AGENDA
Pender County Planning Board Meeting
Tuesday, December 7, 2010 7:00 p.m.
Pender County Public Meeting Room
805 S. Walker Street, Burgaw, North Carolina

RE: Hawksbill Cove Hearing

HAWKSBILL COVE

PLANNED DEVELOPMENT MASTER PLAN (REVISION)

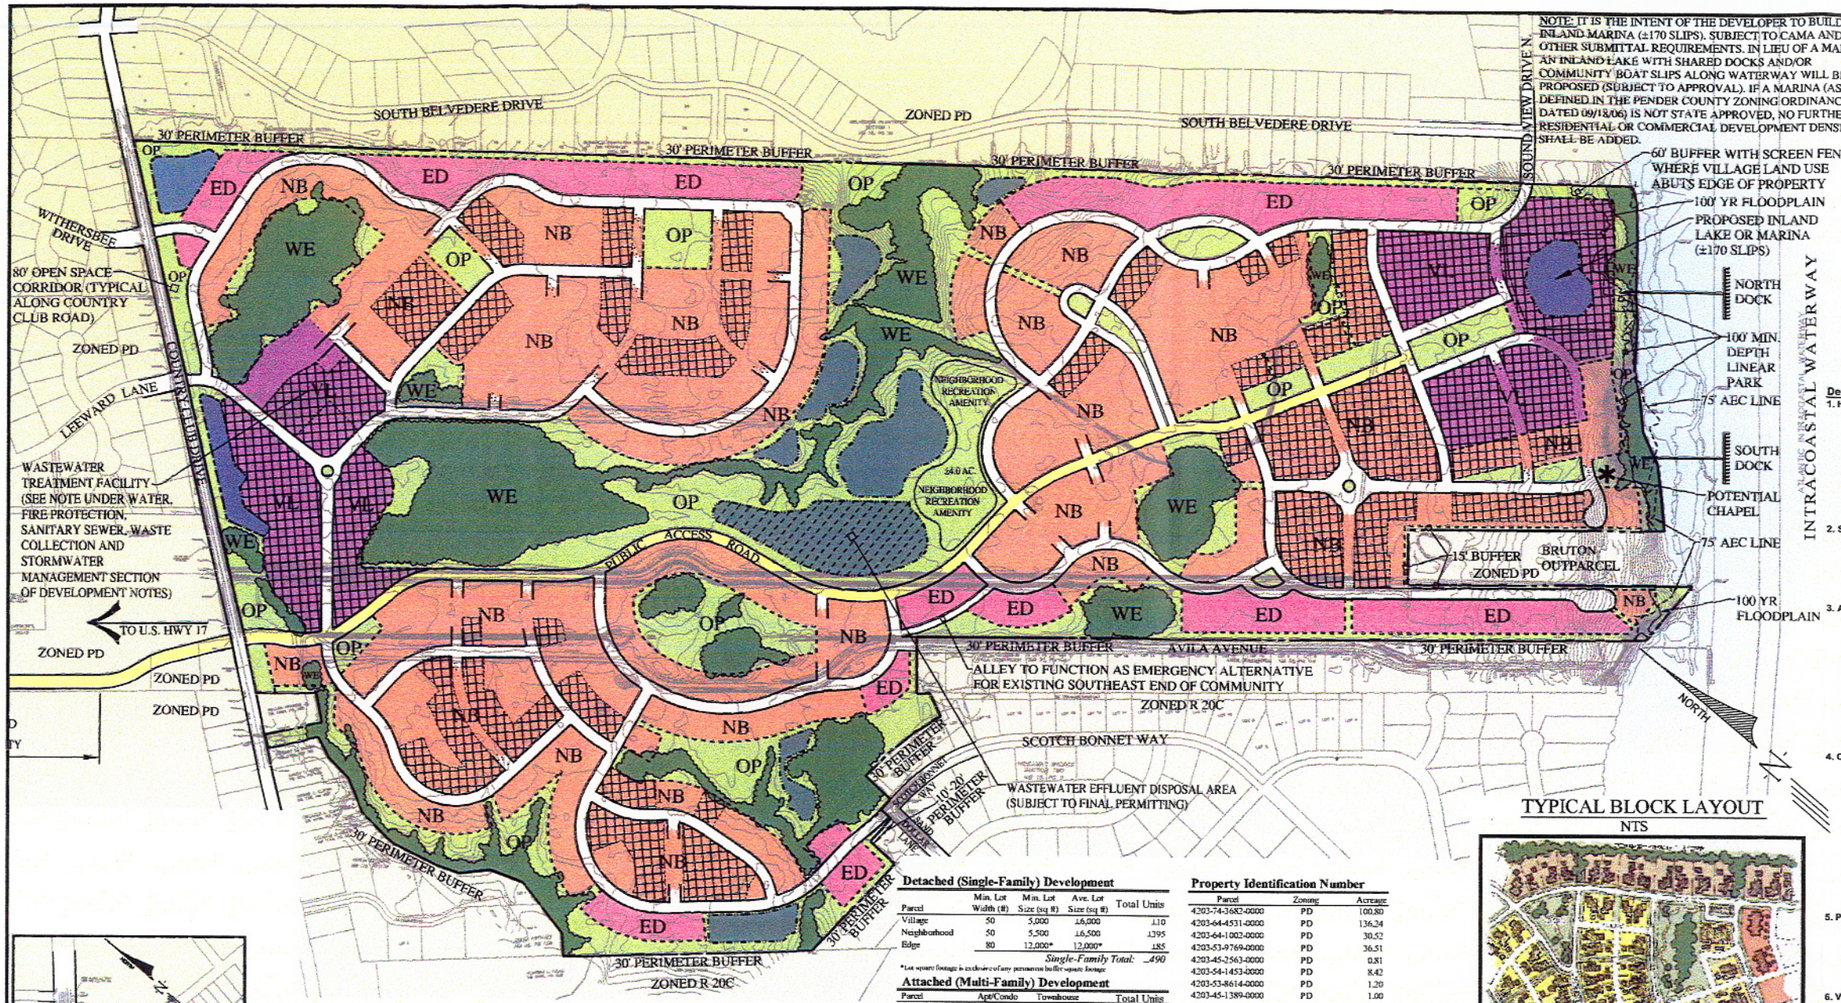
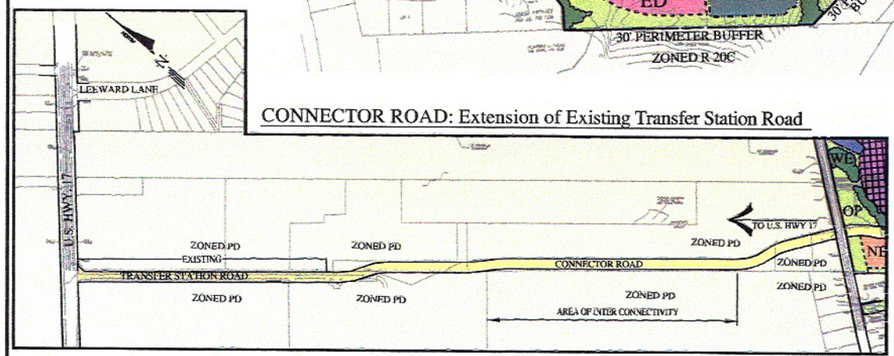
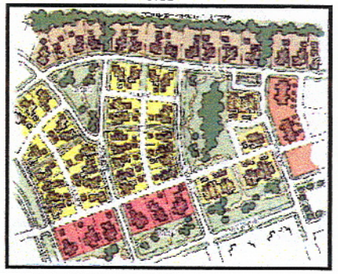
A2. Note on master plan that connector road will be built and binder layer of asphalt before any construction begins in main dev. This means not even street work.

A6. All buffers clearly marked with size and location.

CLARIFICATION FROM BOARD: Make sure the perimeter buffers are all marked and noted.

A8. Would like to see interconnectivity with aquatic center road.

A14. Make note on plan if inland marina is not state approved they cannot come back and add further development (will need to be marked as no development).

B2. Correct buffer width to 60' adjacent to Sound View Drive.

B6. Recommend connections to Sound View Drive and Scotch Bonnet Lane.

B9. Clarify stormwater management methods and treated effluent locations.

RESPONSE: See Note #7 under Development Notes.

RESPONSE: Perimeter buffers have been identified on the master plan. Also see Note #4 under the Development Notes.

RESPONSE: Area of connectivity has been identified on the master plan to allow flexibility for the aquatic center to make connection.

RESPONSE: A note has been added to the existing note in the upper right side of the master plan stating *If a marina (as defined in the Pender County Zoning Ordinance dated 09/18/06) is not state approved, no further residential or commercial density shall be added.*

RESPONSE: The buffer separating the village area from Sound View Drive has been changed to 60' as identified in the previous master plan approval letter dated November 8, 2007.

RESPONSE: Connection to Scotch Bonnet & Soundview Drives has been provided.

RESPONSE: Stormwater management will include a combination of Best Management Practices (BMPs) such as wet ponds, rain gardens, infiltration devices, etc. The Proposed Land Uses legend has been updated to include stormwater and wastewater effluent areas. See Note #8 under Development Notes.

Exhibit A

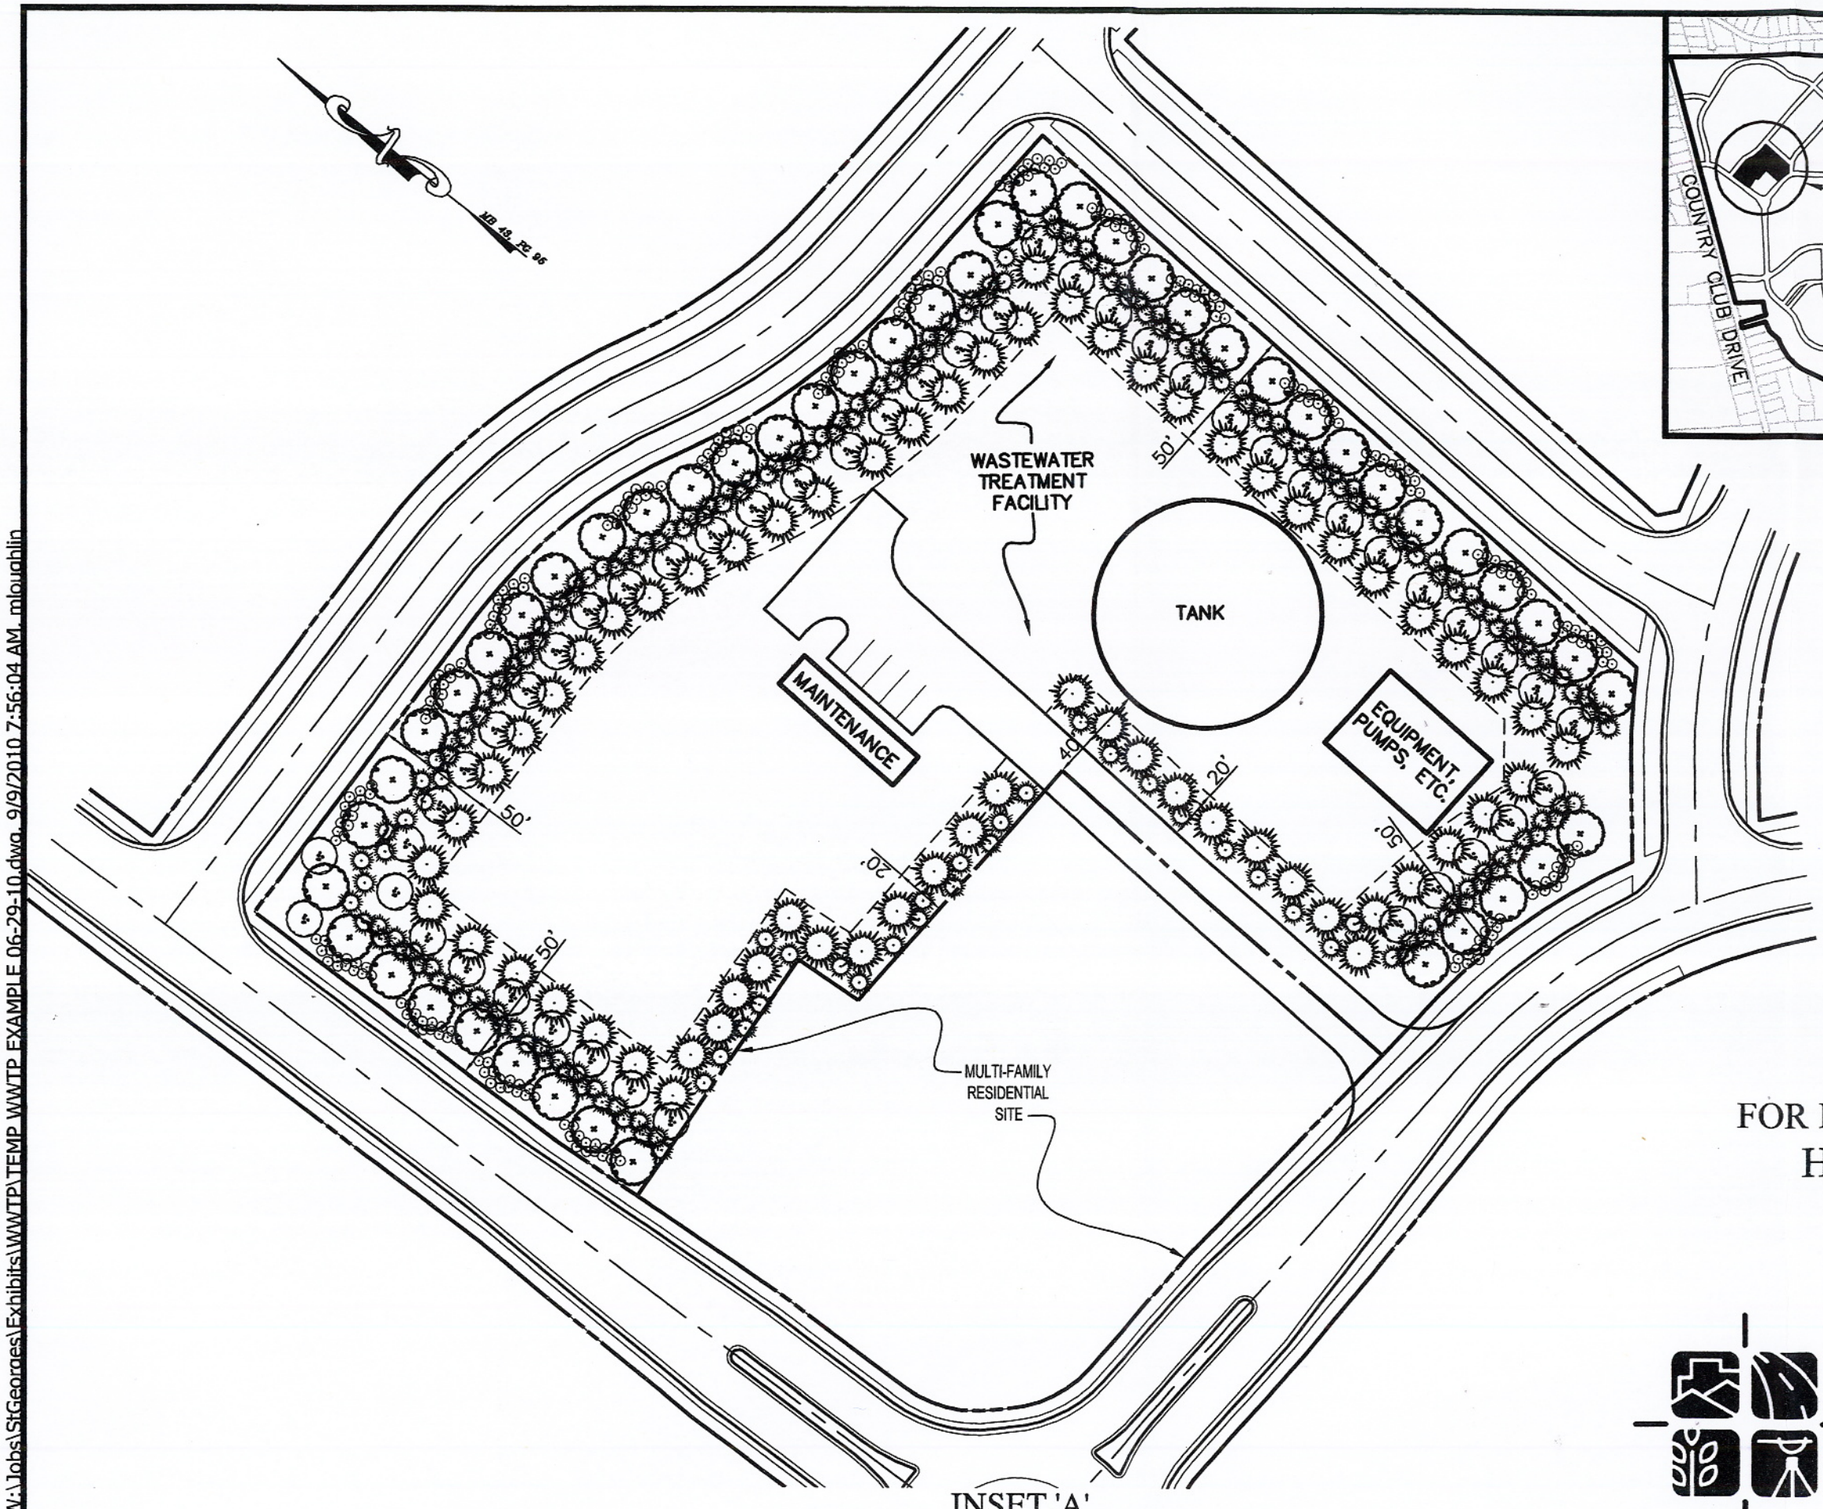
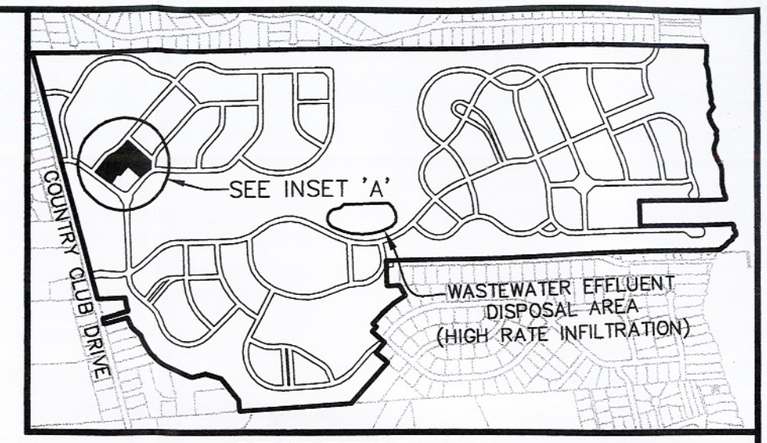
A5. Show location of sewer plant and effluent pond locations and size.

CLARIFICATION FROM BOARD: An 81/2 x 11 supplemental sketch of the site for the sewer plan will be asked to be provided along with the area calculations of the proposed effluent ponds associated with the plant.

Does the area incorporate required buffers to adjacent developed areas?

RESPONSE: See attached Exhibit A dated August 17, 2010 and Exhibit E: letter from Applied Resources Management, PC dated September 7, 2010.

RESPONSE: Yes. See attached Exhibit A.

Transfer Station
Exhibit B

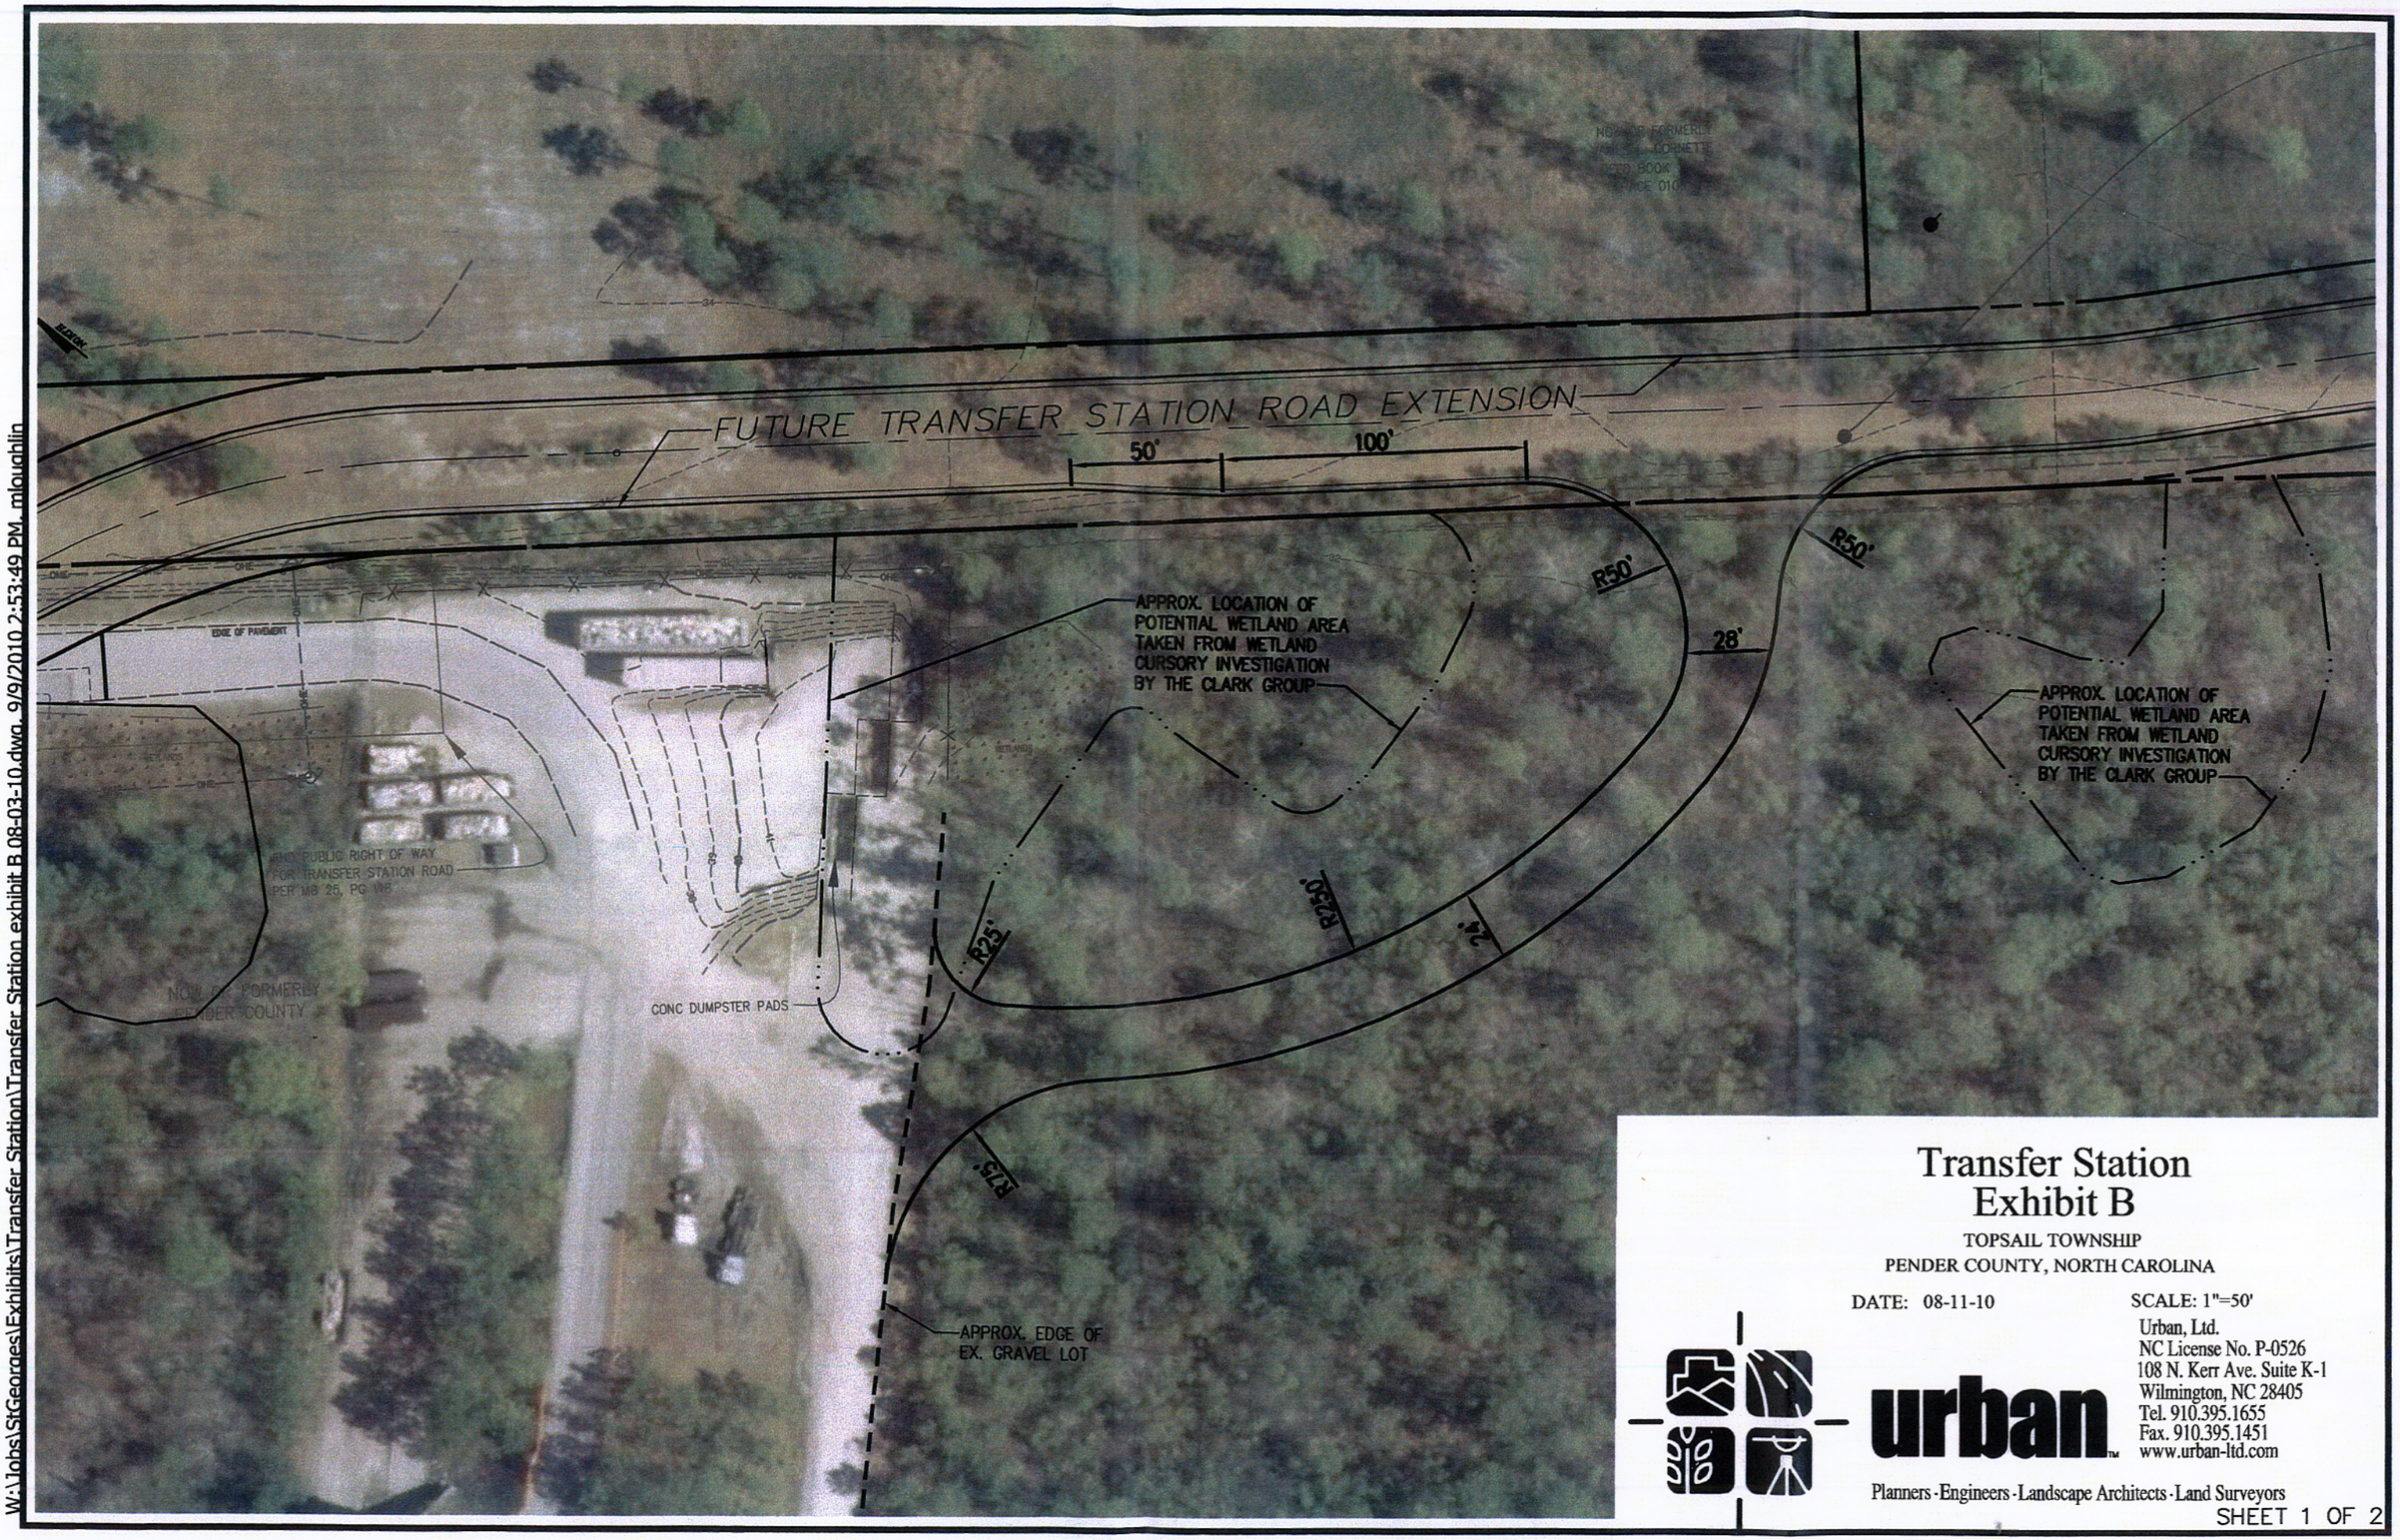
B4. Provide more information on relocation of transfer station.

Specifically, how will truck traffic be accommodated and stacked?

RESPONSE: The transfer station will be heard as an action item at the BOCC meeting on September 20, 2010. See attached Exhibit B dated August 11, 2010 and Exhibit D: Traffic Assessment prepared by Ramey Kemp & Associates dated August 23, 2010.

RESPONSE: The entrance has been located to accommodate better flexibility and a longer entrance drive to accommodate stacking on site as opposed to stacking within public right-of-way as it does today. See attached Exhibit B.

FIGURE 2: TYPICAL CURB & GUTTER CROSS SECTION

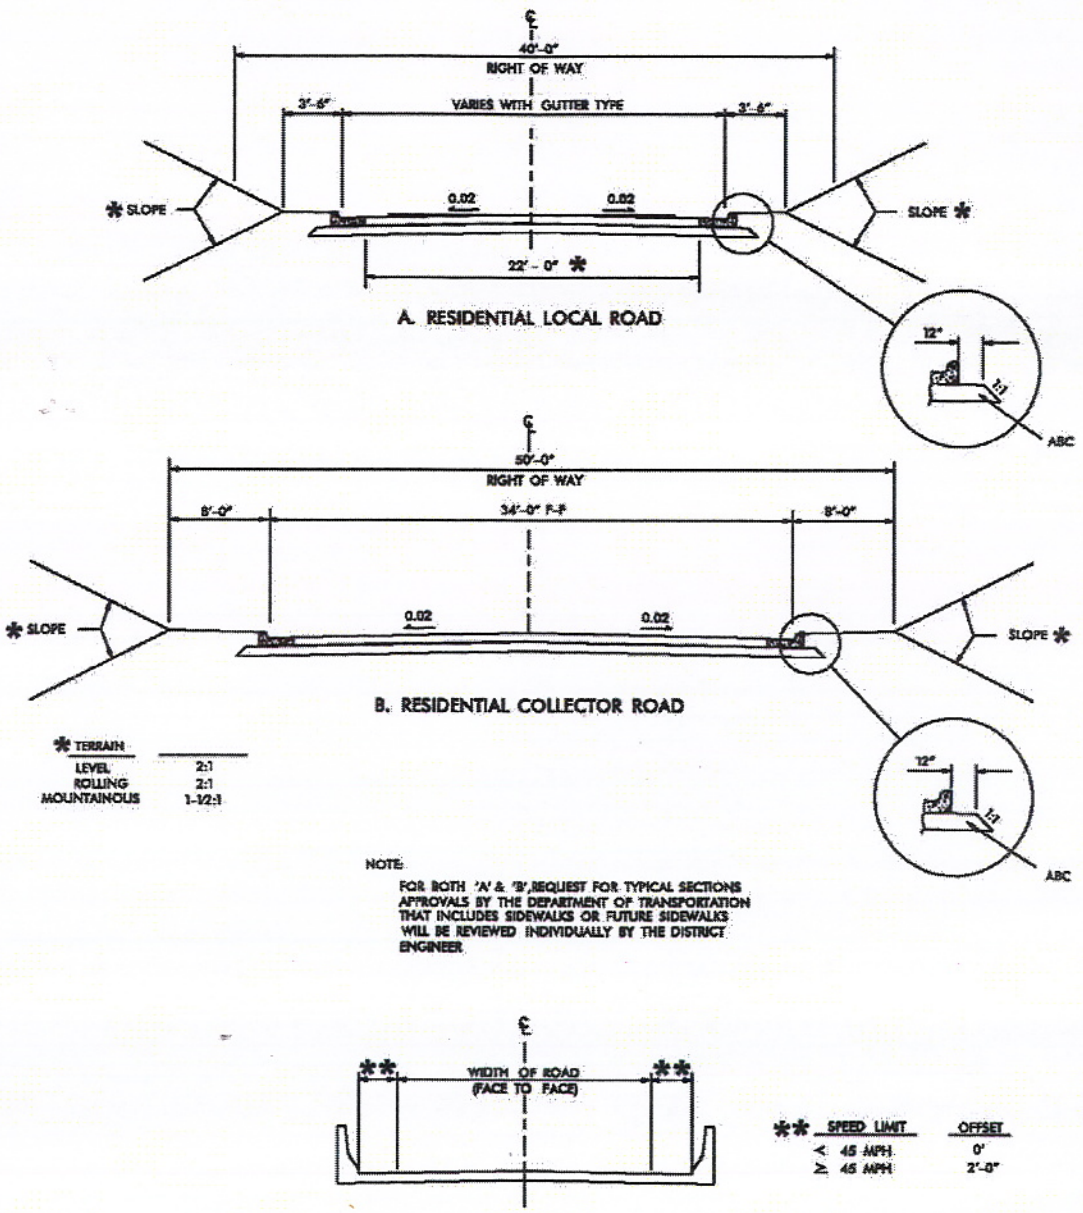
B11. Illustrate bicycle facilities on road cross section.

C4. Please add typical road sections for each road type.

RESPONSE: See attached Exhibit C.

RESPONSE: See attached Exhibit C.
